RE: SITE PLAN (SP2018-020), Chick-Fil-A

Project Number: SP2018-020
Project Name: Chick-Fil-A
Project Type: SITE PLAN
Applicant Name: WIER & ASSOCIATES, INC
Owner Name: CHICK-FIL-A
Project Description:

SITE PLAN
CHICK-FIL-A #03897
SOUTHWEST CORNER OF N. LAKESHORE DR. & GOLIAD ST.

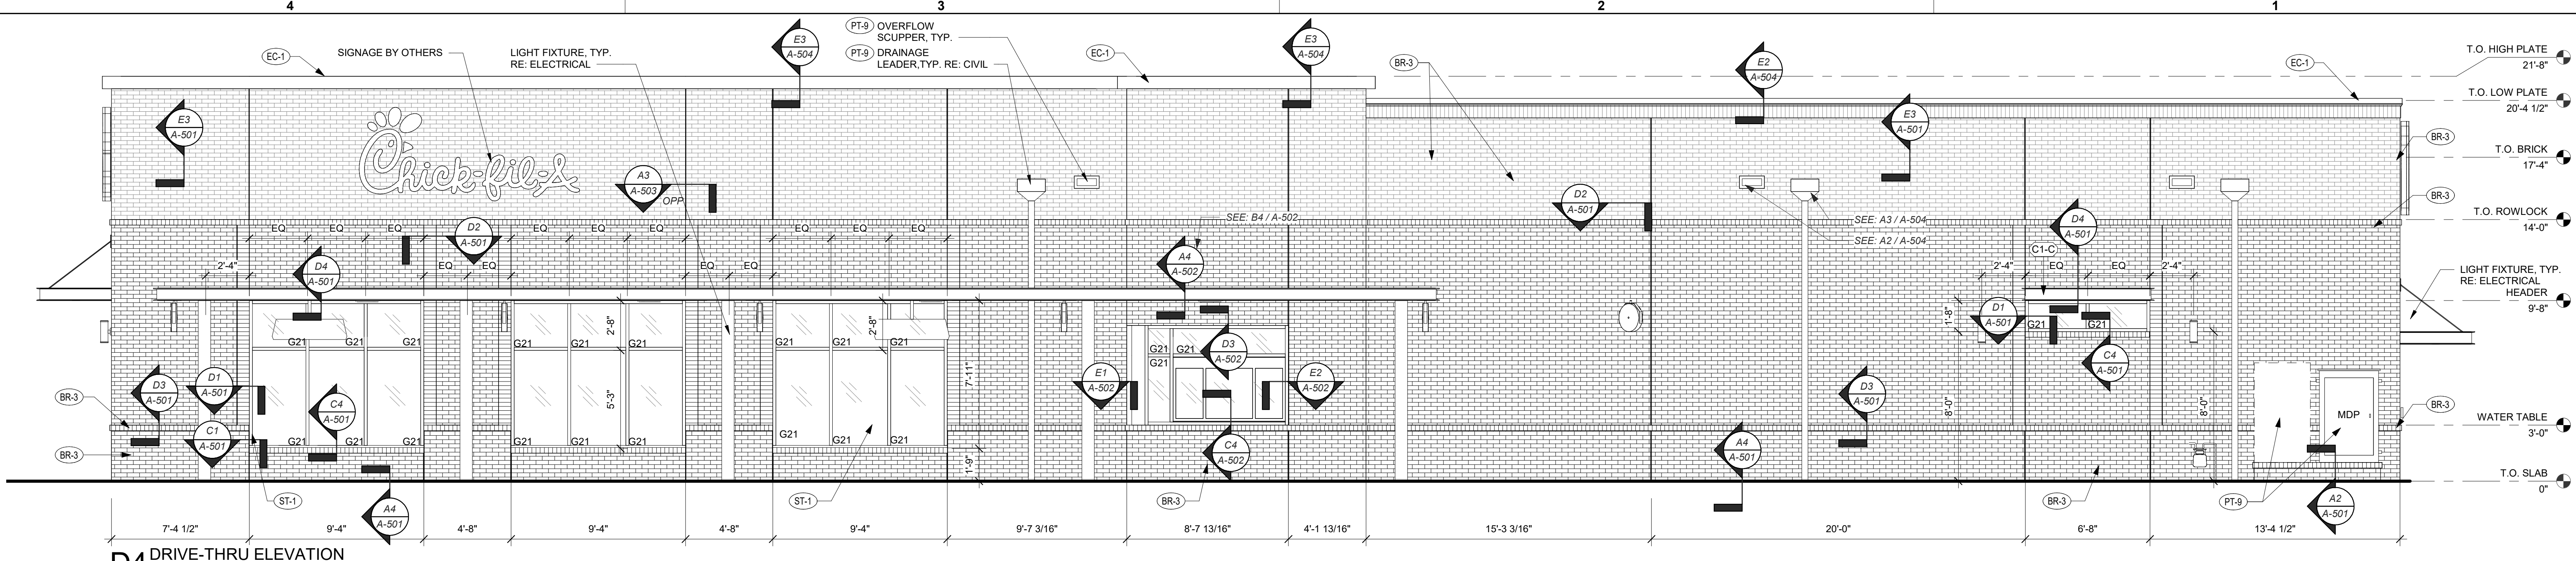
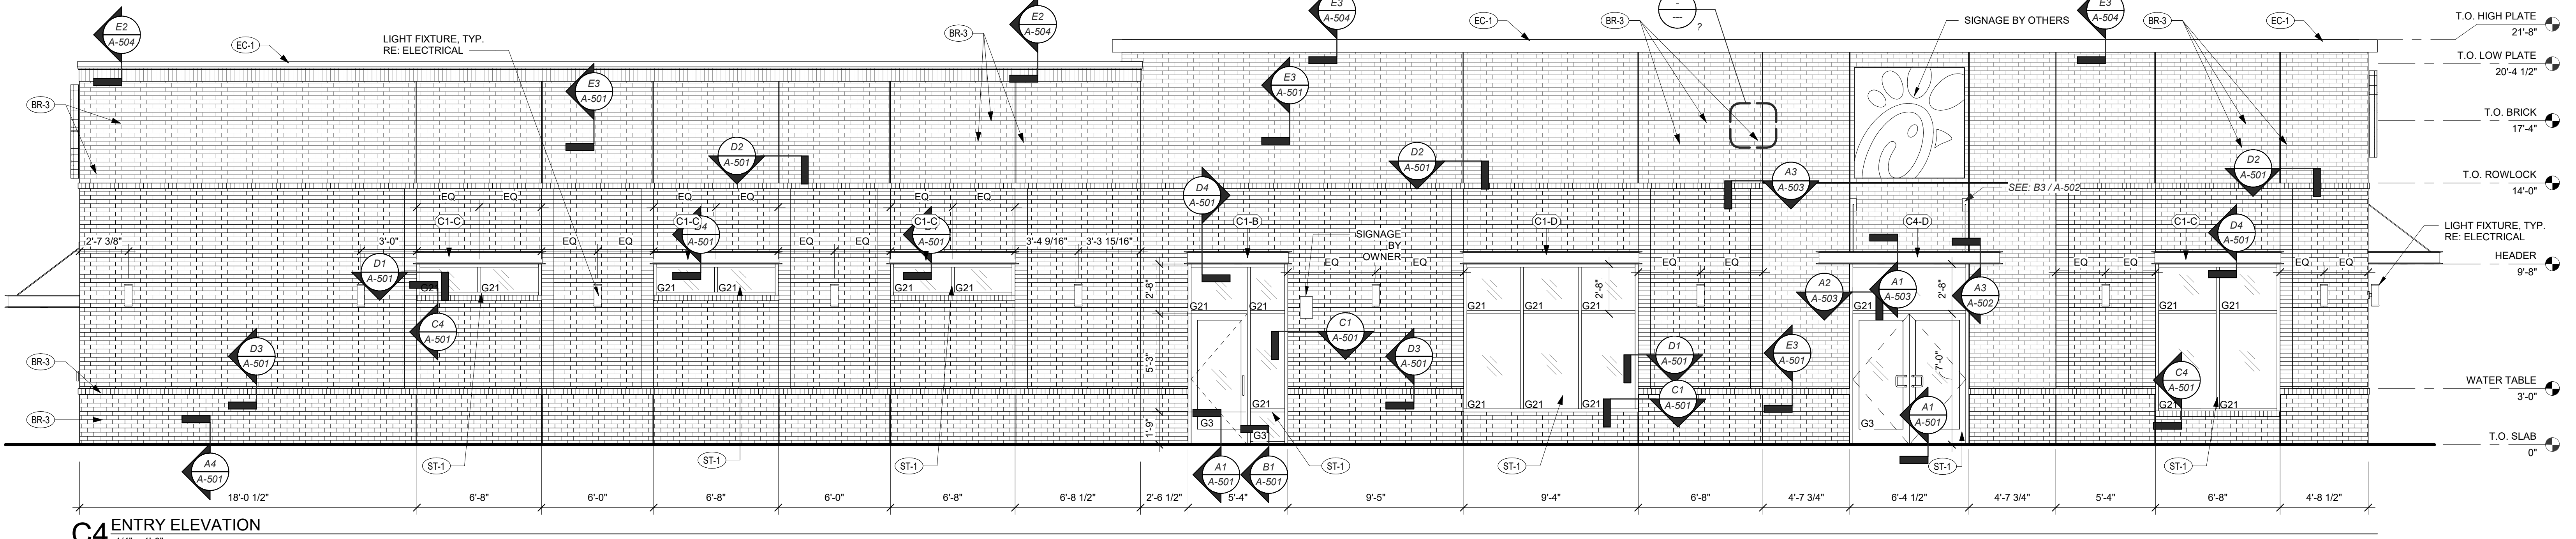
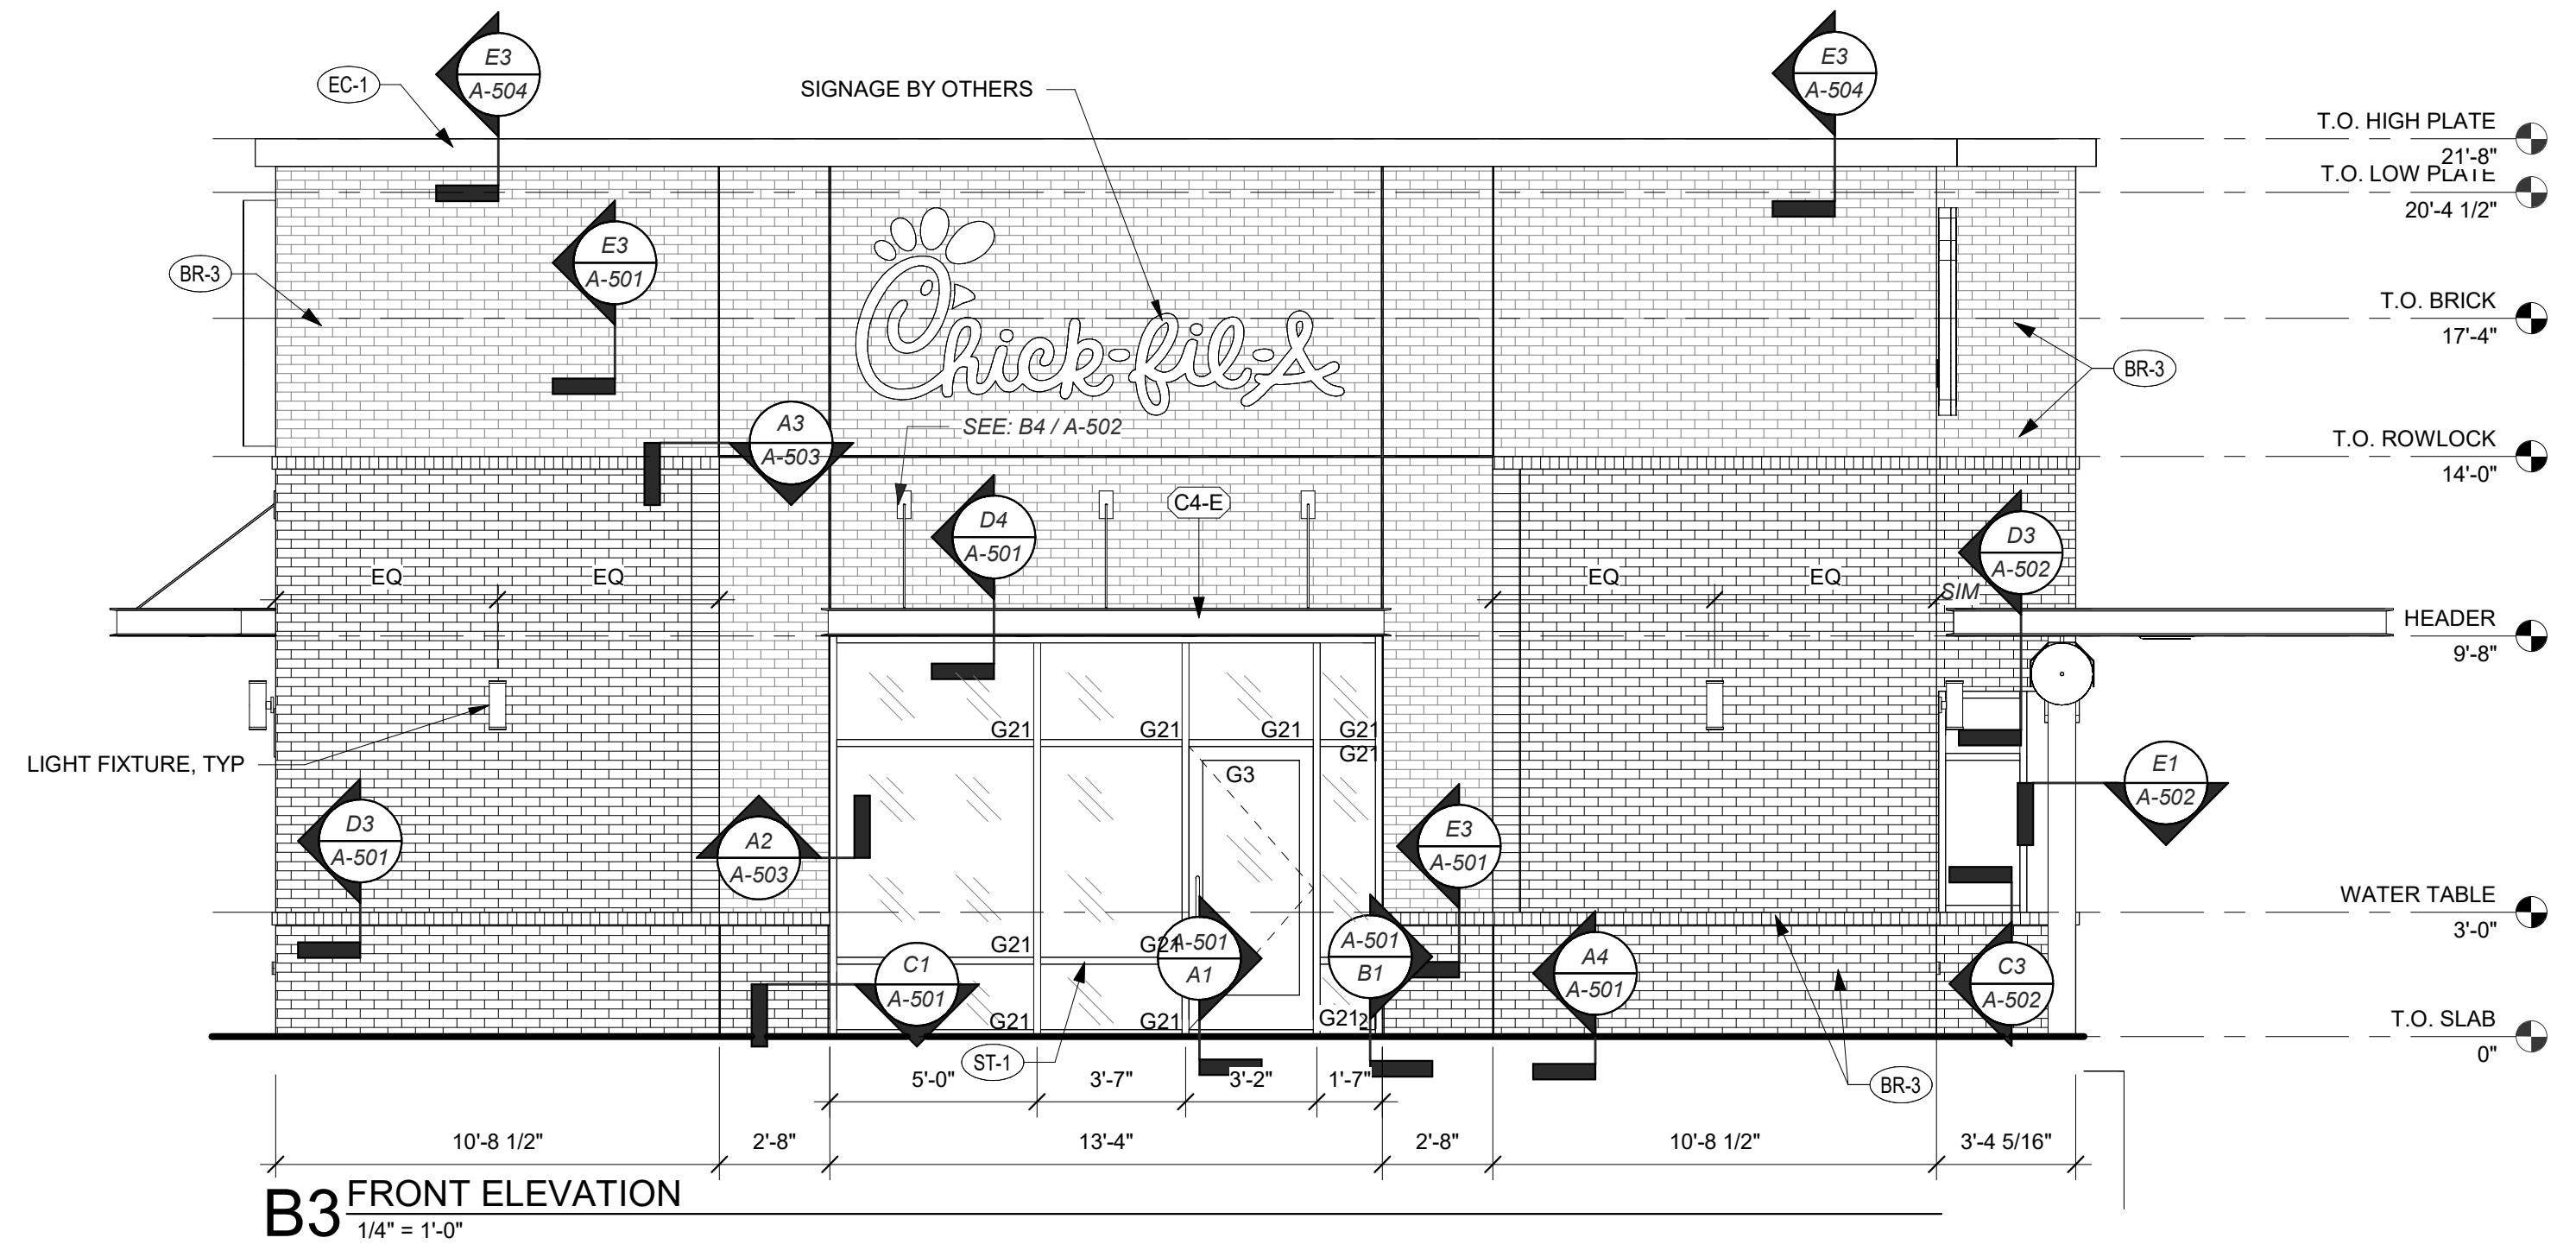
On July 31, 2018 the Architectural Review Board (ARB) reviewed the proposed building elevations and request more vertical and horizontal articulation and revisions to the color of brick and to add stone to blend with the rest of the commercial development. In addition, the Architectural Review Board (ARB) expressed agreement with the requested variance to the pitched roof requirement. The Architectural Review Board (ARB) will review the revised building elevations and forward a recommendation to the Planning and Zoning Commission at the August 14, 2018 meeting.

On August 14, 2018, the Architectural Review Board (ARB) reviewed the revised building elevations and the motion to approve the building elevations and recommend approval of the variance to the pitched roof requirements passed by a vote of 6-0 with Board Member Mitchell absent.
